Agenda Item 3
1206 Estate Lane
New Single-Family Residence on a Vacant Lot

Staff Report
Building Scale Summary
Vicinity Map
Air Photos

1206 Estate Lane

Continued consideration of a new house with an attached garage and the associated hardscape and landscape proposed on vacant property.

SITE PLAN

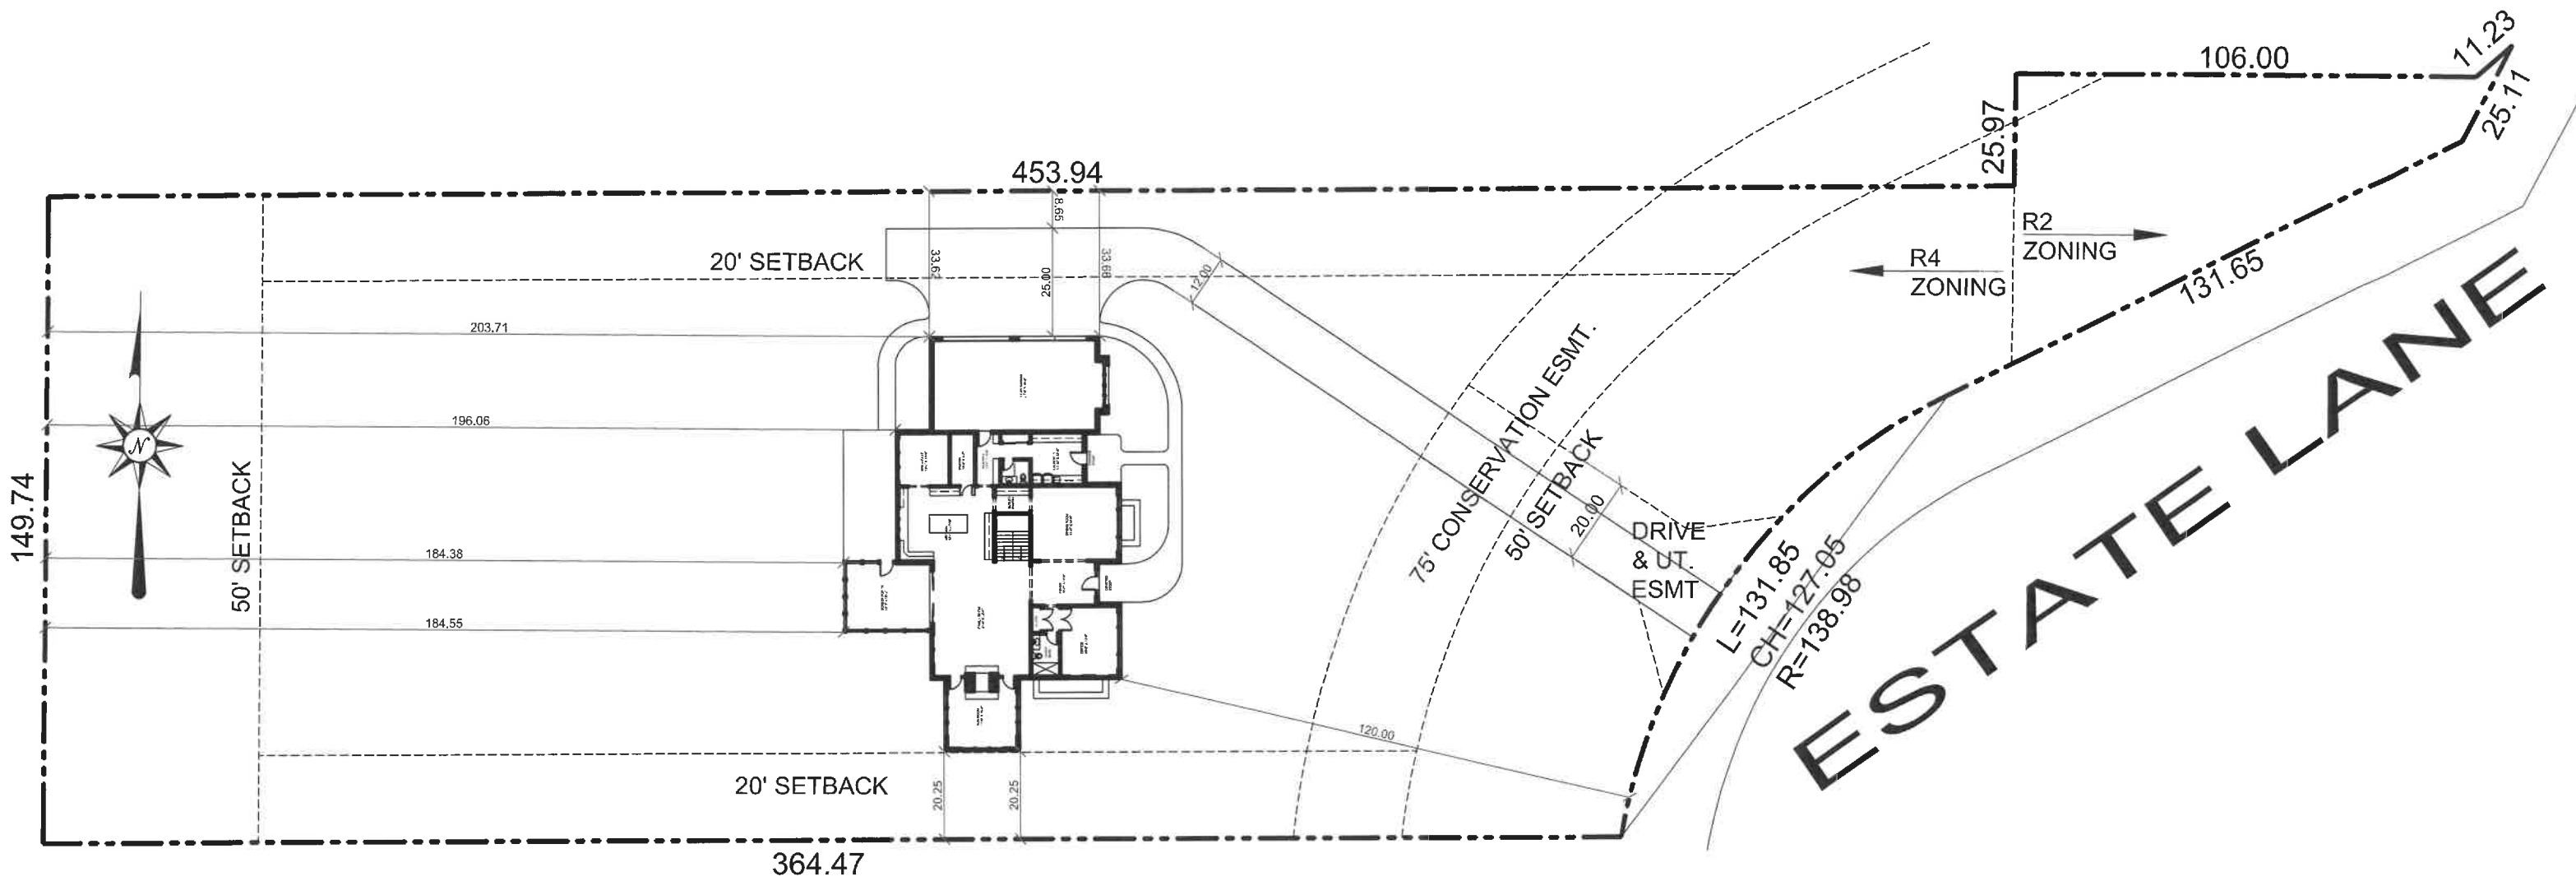
- e. Pull the driveway away from the property line to allow space for plantings and drainage.

The site plan and landscape plan submitted for permit should show the footprints of neighboring homes to the north and south to ensure that sufficient landscape screening is provided.

Staff Recommendation: Show the footprints of neighboring homes to the north and south on the site plan to allow evaluation of whether adequate landscape screening is proposed.

LANDSCAPE PLAN

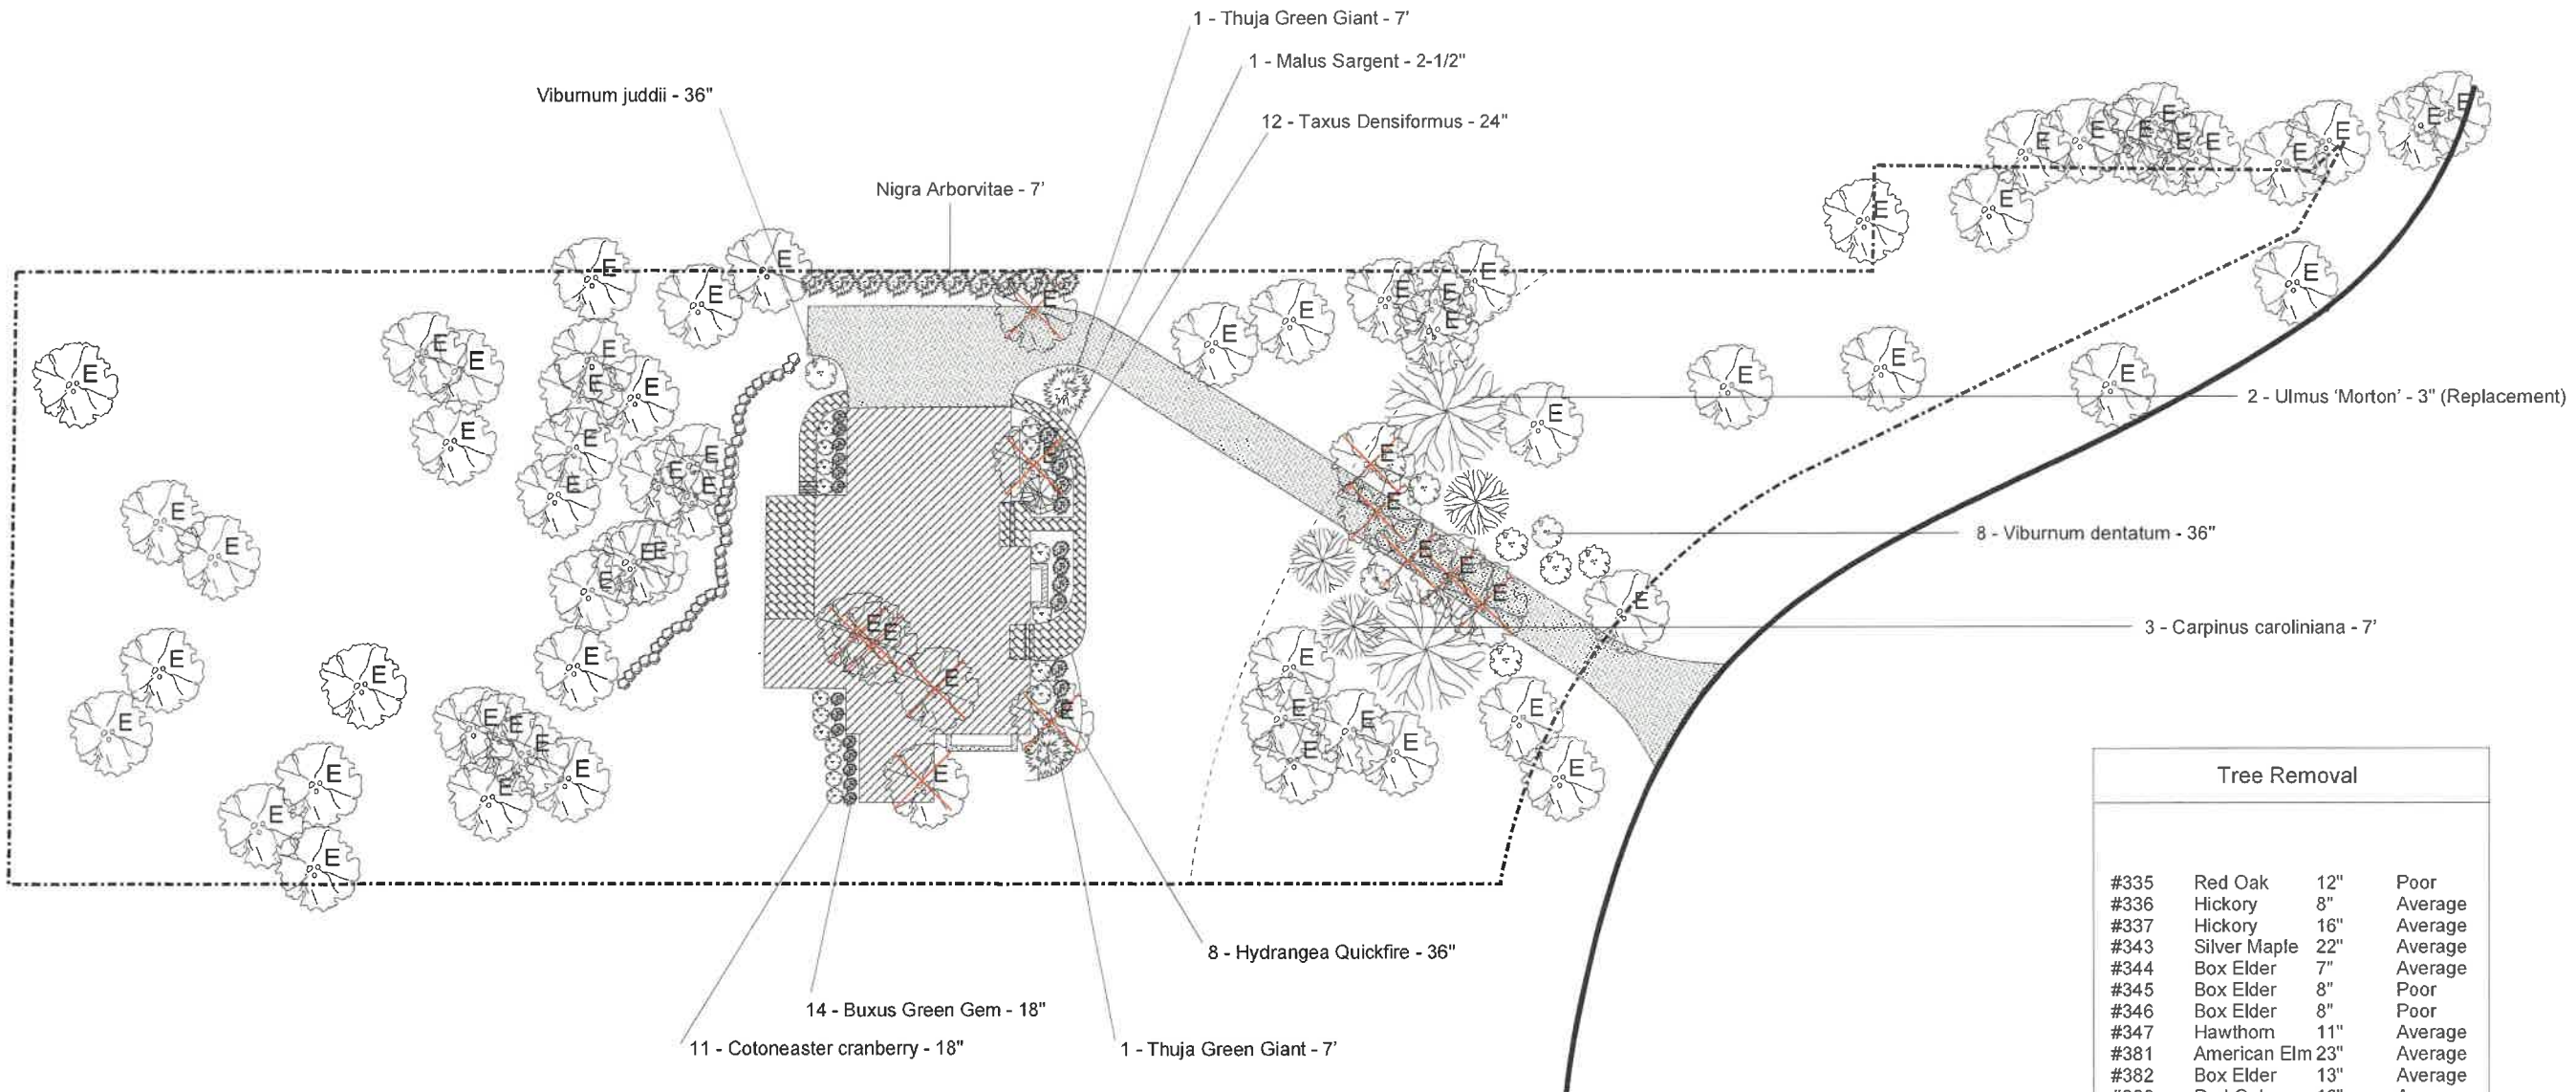
- b. Submit a conceptual landscape plan demonstrating inch-for-inch on site replacement of trees proposed for removal. (The final landscape plan must demonstrate alignment with the drainage and grading plan.)
The landscape plan does not yet demonstrate inch-for-inch on site replacement of trees proposed for removal.

The landscape plan does not yet reflect plantings which will restore the wooded streetscape intended at the time of subdivision.

The preliminary landscape plan appears to meet the minimum requirements for new homes. The plan clearly identifies the trees proposed for removal. According to the tree removal plan, 12 trees are proposed for removal, including healthy oaks and hickories. The current plan does not adequately demonstrate inch-for-inch replacement of the removals of these high quality trees.

To screen the private areas of the neighboring property to the south from the proposed home, vegetative screening should be reflected on the landscape plan along the south property line. The landscape plan should show the footprints, or partial footprints of the neighboring houses to the north and south.

Staff Recommendation: Submit a final landscape plan drawn on the grading and drainage plan, demonstrating inch-for-inch replacement of trees proposed for removal, plantings proposed for the Conservation Easement, and plantings to buffer the neighboring homes to the north and south. The plan should reflect the footprints, or partial footprints, of the homes to the north and south.

Staff Recommendation: The landscape plan shall reflect plantings within the Conservation Easement including ground cover, mid-level plantings, and canopy trees to restore the wooded streetscape intended at the time of subdivision.

NORTH AND SOUTH ELEVATIONS

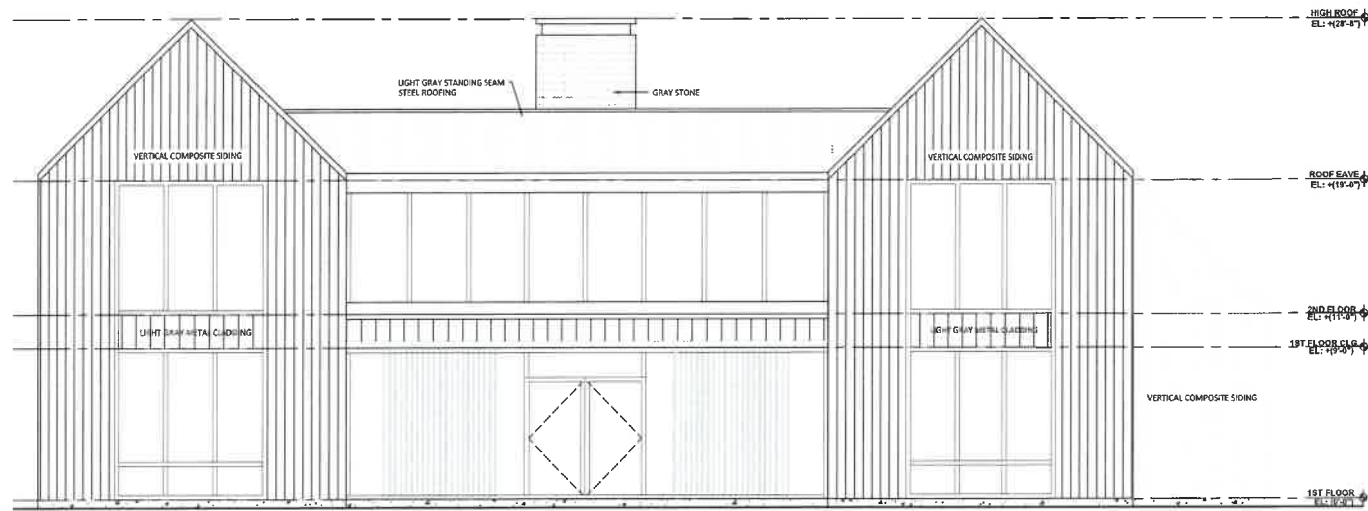
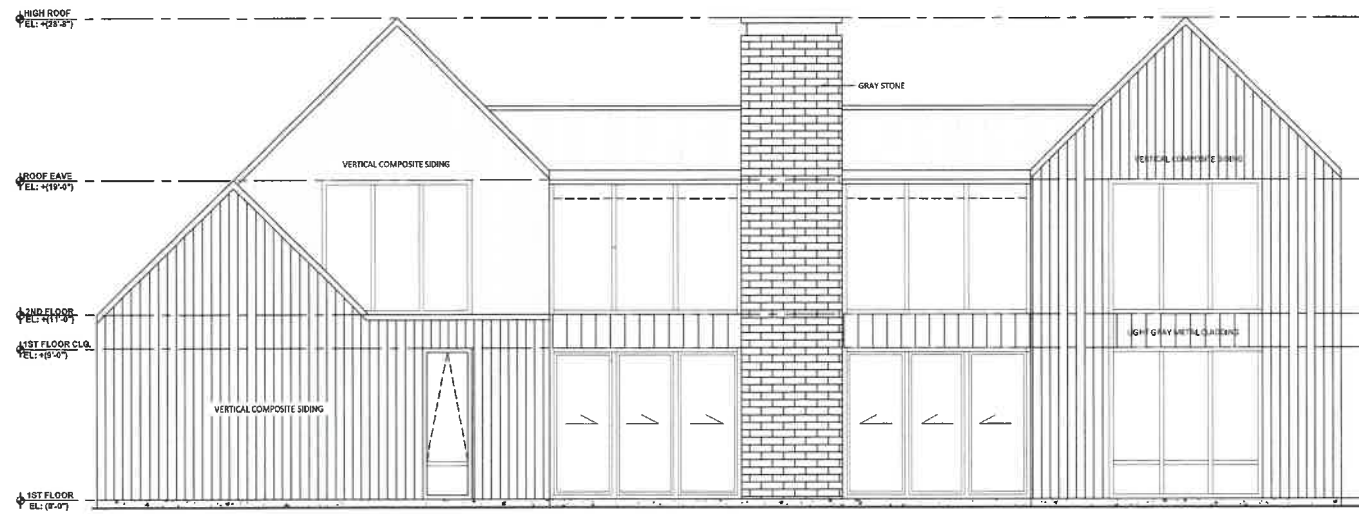
On the north (front) elevation, modifications have been made to soften the visibility of the expansive first floor glazing from the streetscape. Vertical slats are now proposed on either side of the front doors creating an enclosed porch-like feature. The slats are approximately seven feet from the glass, adding depth and shadowing to the façade, reducing direct visibility into the interior, and mitigating potential light spillover. The roof

Additional refinements made to soften the appearance of the front elevation include modifications to the roof and overhang. The depth of the overhang at the second floor was increased to two feet.

In further response to Board direction regarding light impacts, the front entry doors have been revised from glass to wood, and the garage doors are now proposed as wood rather than glass.

The vertical slats have been shifted outward 7' to create an intermediate entry zone. This softens the perception of the building and provides additional depth. The roof overhang has also been extended, which further grounds the façade. The revised slat configuration frames the exterior views while limiting direct visibility into the interior.

Roof height, slope, and overhangs have been modified. The second-floor front elevation now includes a 2' overhang, and the rear elevation incorporates an overhang extending over 5' and wrapping around the chimney. These adjustments reduce the perceived building mass and create a more cohesive roof expression.

TREE REMOVAL AND LANDSCAPE PLAN

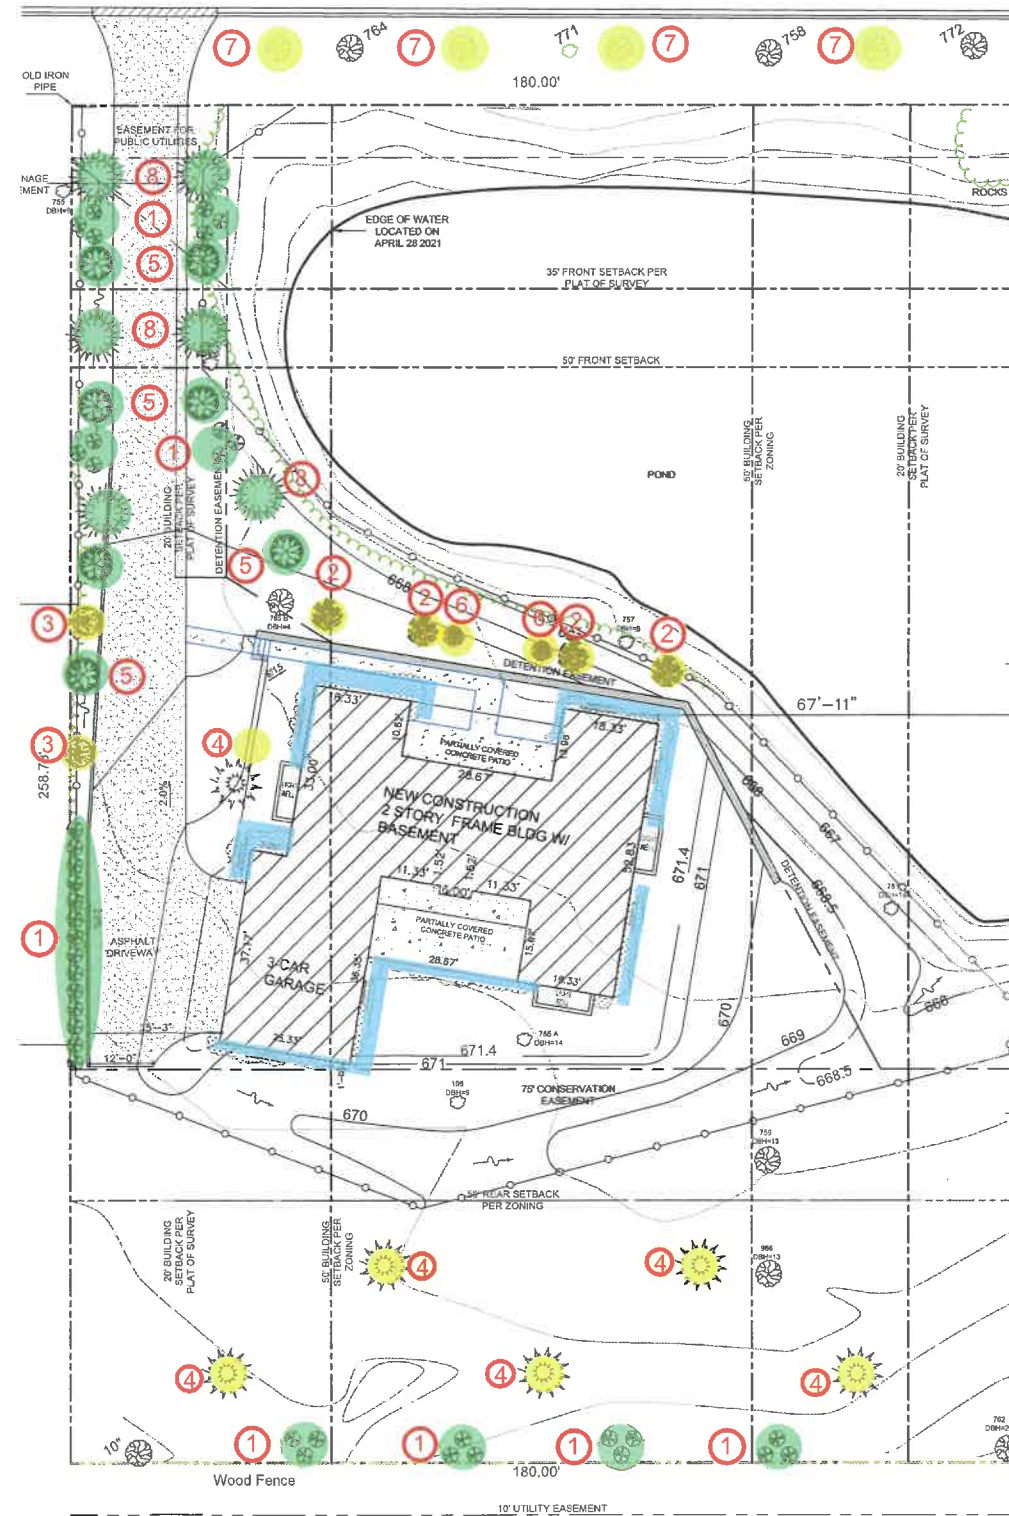
In response to comments and direction from the Board, the west property line is staked. The stakes demonstrates that the hedge is completely on the 1241 Ashlawn Drive property. Vegetative screening along the property line should remain or if removed, should be replanted to sufficiently screen the neighboring home to the west from the driveway and car headlights.

Grading and tree planting in the Conservation Easement which extends along the south property line is proposed. According to the plat of subdivision, the Conservation Easement is to remain in its current landscaped state and maintained using good forestry practices. Clearing may be permitted with prior City approval subject to submittal of a replanting plan determined by the City to restore a density that provides a vegetative buffer. Ordinarily, regrading or filling within a Conservation Easement is not permitted. In this case, given the siting of the house, it appears that very limited regrading may be necessary. Any grading should be limited to the minimum required and any disturbed area must be replanted and remain undisturbed going forward. An escrow deposit will be required at the time of issuance of a building permit to ensure replanting of the Conservation Easement consistent with the plan approved by the City.

The tree removal plan identifies 6 trees of varying species, size, and condition for removal. Overall, the six trees proposed for removal are not high quality species. The proposed landscape plan appears to meet the minimum criteria for new construction and demonstrates compliance with the inch-for-inch replacement requirement. The plan appears to show sufficient year round vegetative screening across from the garage to mitigate car headlights. The species indicated on the plan do not all represent native species. Particularly, within the Conservation Easement, native species are required including grasses, shrubs, and trees.

Additional landscape has been incorporated, including plantings within the conservation area near the property line.
